**STAFF REPORT: MAY 10, 2023 MEETING**

**APPLICATION NUMBER: 23-8331**

**ADDRESS: 4071 LESLIE**

**SCOPE: REPLACE ORIGINAL WINDOWS WITH WOOD ALUMINUM-CLAD WINDOWS**

1999 district designation photo, Historic Designation Advisory Board.

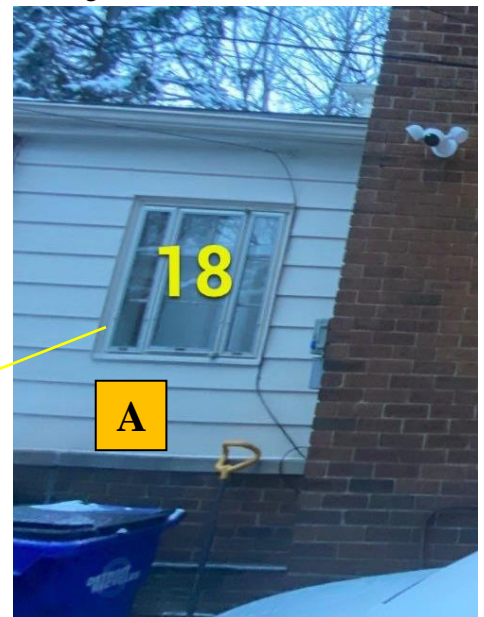
- The 1999 designation photo shows the following alterations that were present at time of designation:

- Glass block was in place adjacent to the front door; this was not an original condition. Staff has no visual confirmation of the original window design.
- An a/c unit is in the second floor window on the east elevation. This gives substantiation as to why the existing window was so heavily altered.
- The metal awning and supporting iron posts that were installed in 1967 are evident. The only remaining visual clue of this installation is a thin horizontal white paint line above the front door and windows.

FRONT ELEVATION

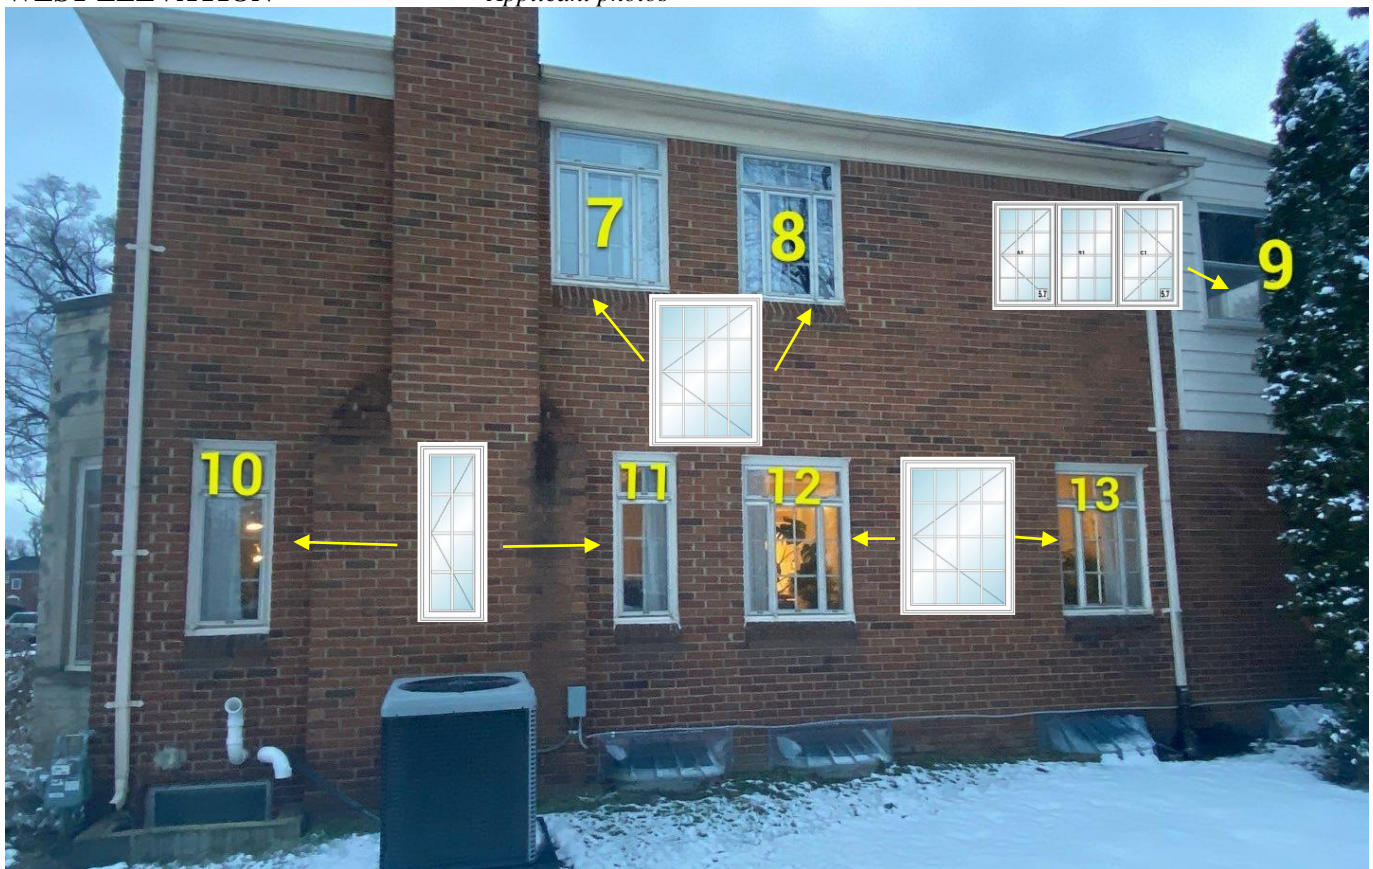
*Staff photo, April 26, 2023. The rough opening width of the first and second floor openings are the same; the upper windows are approximately 12” shorter in height. The single casement side windows in the first floor bay would mimic the operation and design of the existing windows, whereas the other openings change operation and appearance.*

**Recommendation One – Denial – Replacement of original windows**

Staff finds that the proposal for the replacement of the original windows with aluminum-clad wood replacement windows would remove distinctive features that characterize the property thus altering the features and spaces that characterize the property and district, which does not meet the Secretary of the Interior’s Standards and the Russell Woods-Sullivan Historic District’s Elements of Design for the following reasons:

- The multi-operational arrangement of window sash within window openings is a common feature in Russell Woods and is a distinctive character-defining feature of this house.
- The selected replacement windows do not emulate the profile, pattern, and operation of the existing windows and would alter the features that characterize the property.

Staff therefore recommends that the Commission issue a Denial for the work as proposed, as it does not meet the district’s Elements of Design #3 as well as the Secretary of the Interior’s Standards for Rehabilitation, specifically Standards 2, 5, 6, and 9:
